Hinkley Point C Connection Project

Requirement 9 Provision of Embedded Landscape Mitigation and Landscaping Scheme for Sandford Substation – ‘Non-Advanced’ Planting

Document 6 9 1 D

October 2021

Figure 9: View looking east within Planting Phase Area C

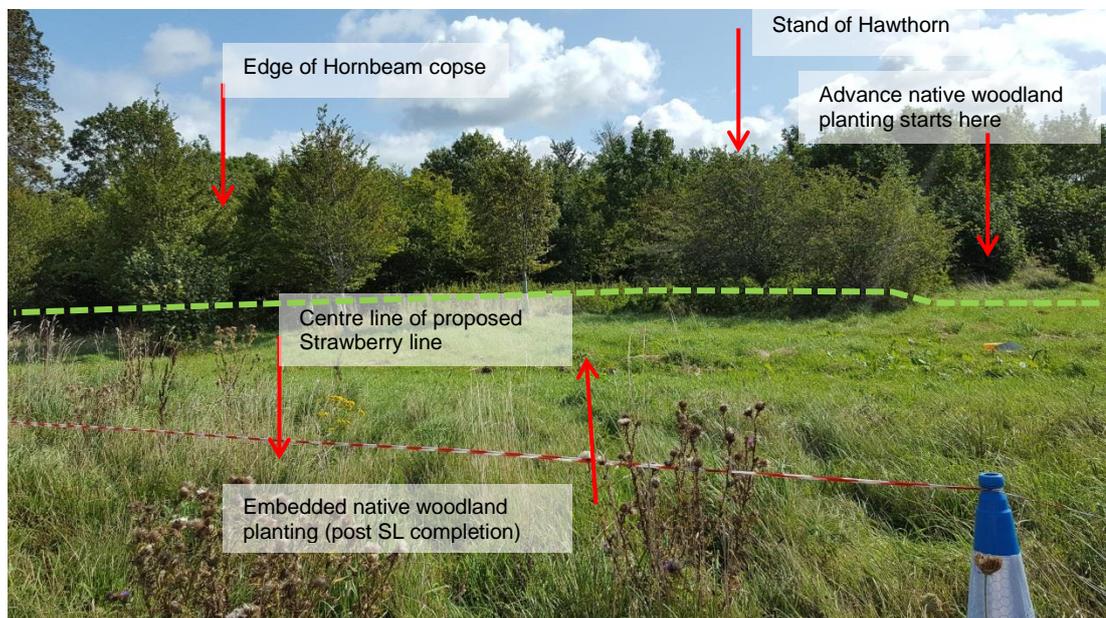
Type of comment	Consultee	Comment	Response
Specific comment	Landscape Officer (NSC)	<p>Phasing</p> <p>Updated phasing of the planting is set out at 2.3.1. (the advance planting (part) indicated was completed this April). I have no objection to the indicated phasing.</p> <p>Detailed Design</p> <p>The detailed design has been modified to take account of a number of scheme changes at 3.1.5 and revised proposals for the non-advance landscape scheme are included at Appendix C.</p>	Comments noted, no response considered necessary.
Specific comment	Landscape Officer (NSC)	<p>Following a comparison of the DCO approved and the updated landscape scheme quantities for all planting areas (table 3), the document goes on to explain the rationale for the planting of each area (A to I):</p> <p>Table 7: Landscape Scheme Extracts for Planting Phase Area C</p> <p>The DCO scheme and masterplan illustrate an area of existing orchard to be retained and enhanced, but it no longer appears on the updated plan. Please clarify as there is no mention of this in the text.</p>	<p>The original DCO scheme and masterplan had shown an existing orchard in a formal grid layout. Further to a vegetation survey along the proposed Strawberry Line undertaken in September 2019 this orchard is in fact a copse of Hornbeam which does not reflect the formal grid layout shown on the original DCO scheme. The vegetation survey undertaken in September 2019 picks up the edge of the existing Hornbeam copse only where this interfaces with Planting Area C.</p> <p>Please refer to paragraph 3.4.4, Figure 9 and Figure 10.</p>
